VCBO® ADDENDUM 001

project	Intermountain PKH Sports Performance Center Phase 2	project no	20065.01
date	2023-10-25	no. pages	
owner	Intermountain Healthcare		
contractor			
bid date	2023-10-30	bid time	4:00 pm

Project: INTERMOUNTAIN PARK CITY HOSPITAL - SPORTS PERFORMANCE CLINIC

Revision: Addendum 001

1 PLUMBING DEMO PLAN FIRST FLOOR - AREA 1
SCALE: 1/8" = 1'-0"

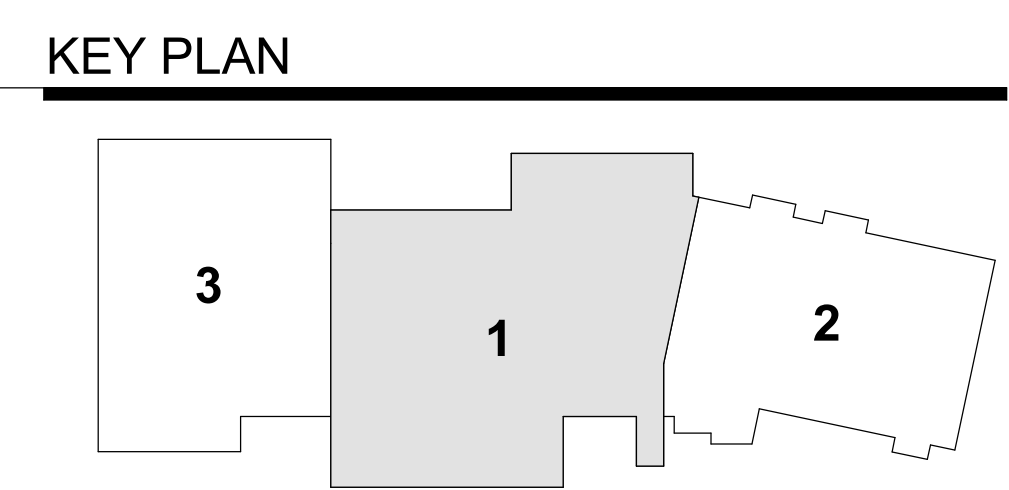
- Demolition of existing sinks where the laser procedure room is going.
- Keyed note 3 added to sinks shown where the physiology lab is going.

- Keyed note three added to handwashing sink to be demolished.
- Water outlet and floorsink to remain in place.
- Keyed note 7 removed.
- Keyed note 8 changed to keyed note 6.

PLUMBING PLAN FIRST FLOOR - AREA 1 (PHASE 2)
PP111.1-2

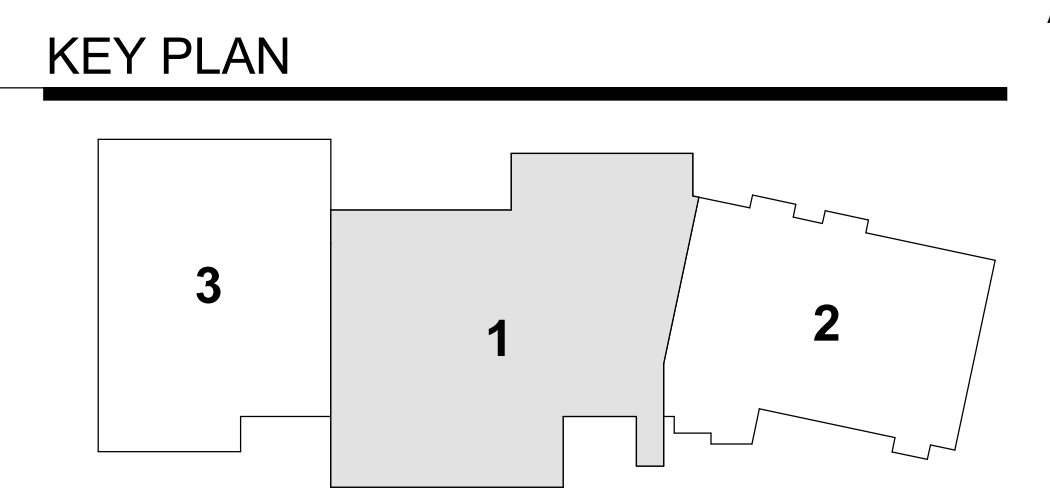
- Sink in Physiology Lab shifted.
- Existing floor sink and water outlet remaining in place. Pipes shown extending to new water outlet and floor removed.
- New sinks in Sports med called out.
- S-1 added in Laser Procedure.
- Note 13 changed to note 9
- Note 14 changed to note 8
- Note 15 changed to note 6
- Note 16 changed to note 5
- Note 17 changed to note 3.
- Note 18 changed to note 2.
- Notes 10 and 11 changed.
- Note 12 removed.

FIRE PROTECTION
DEMOLITION PLAN
FIRST FLOOR - AREA 1
(PHASE 2)
FPD111.1-2

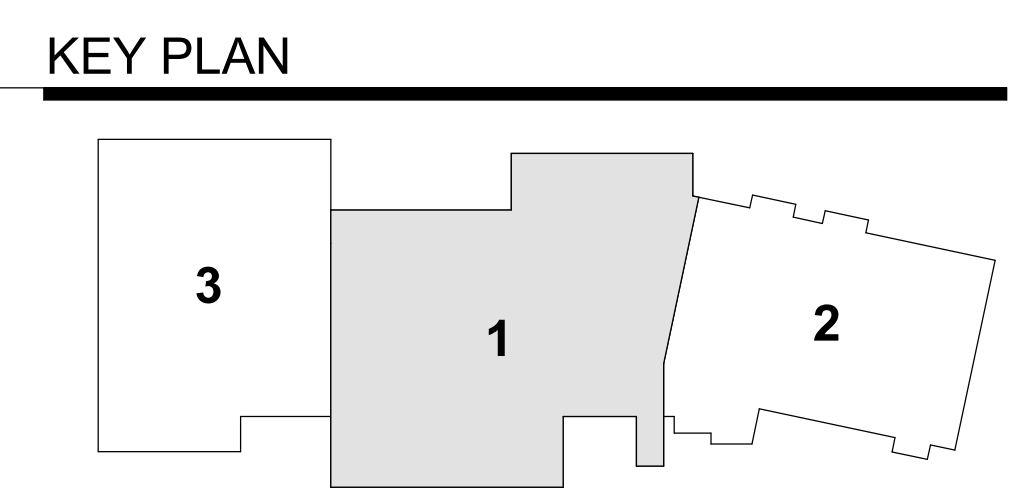
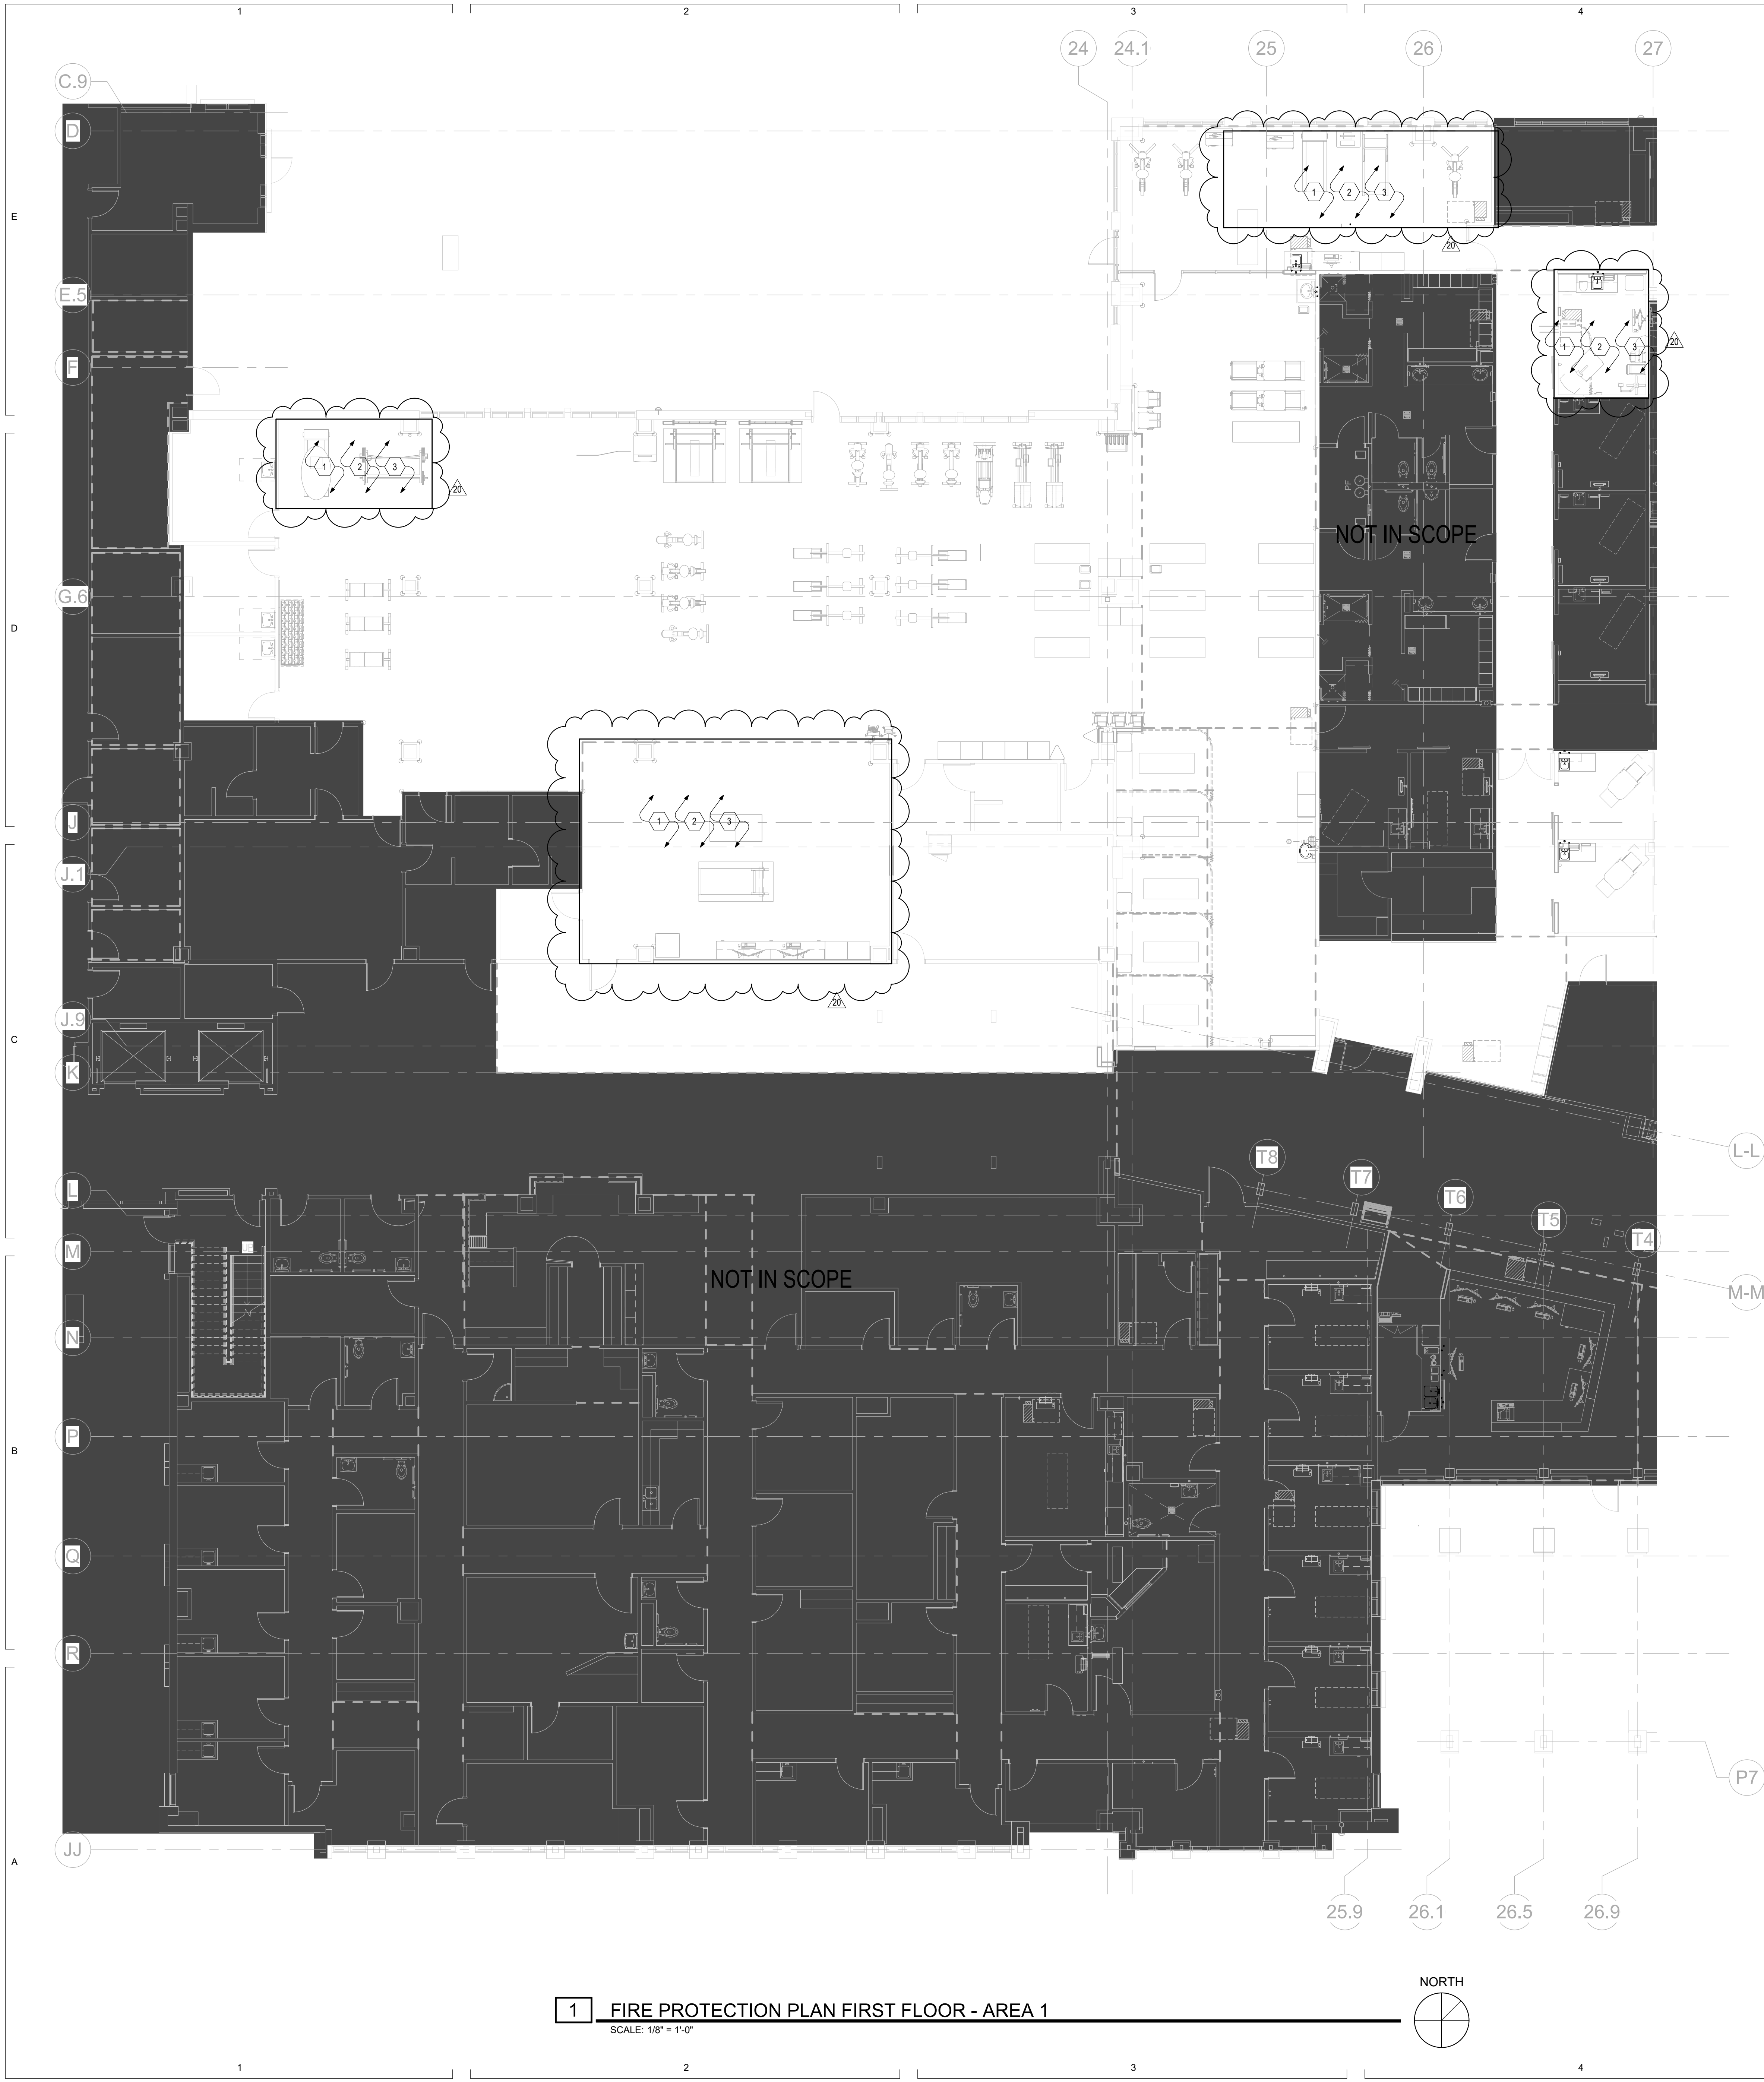
- Keyed note one moved on page clarifying scope of work.

FIRE PROTECTION
 PLAN FIRST FLOOR -
 AREA 1 (PHASE 2)
FP111.1-2

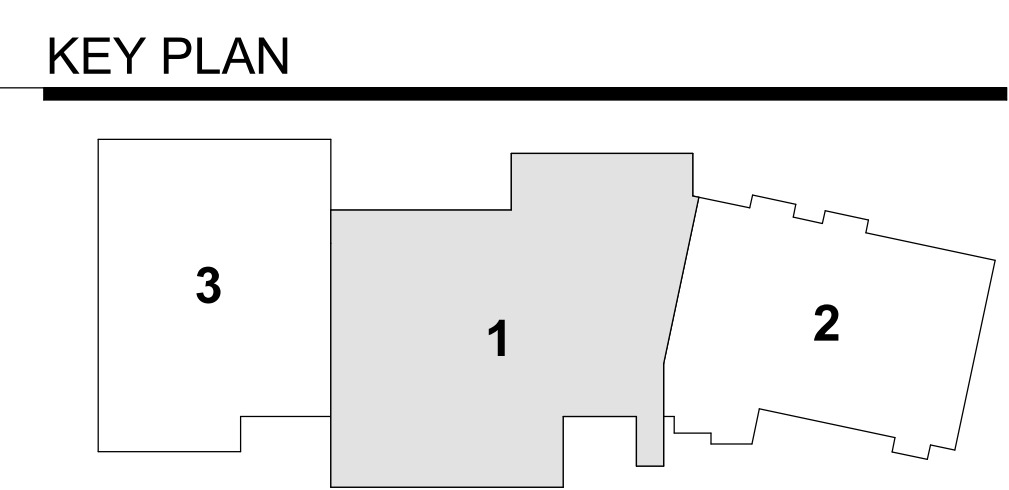
- Keyed notes moved on sheets clarifying scope of work.
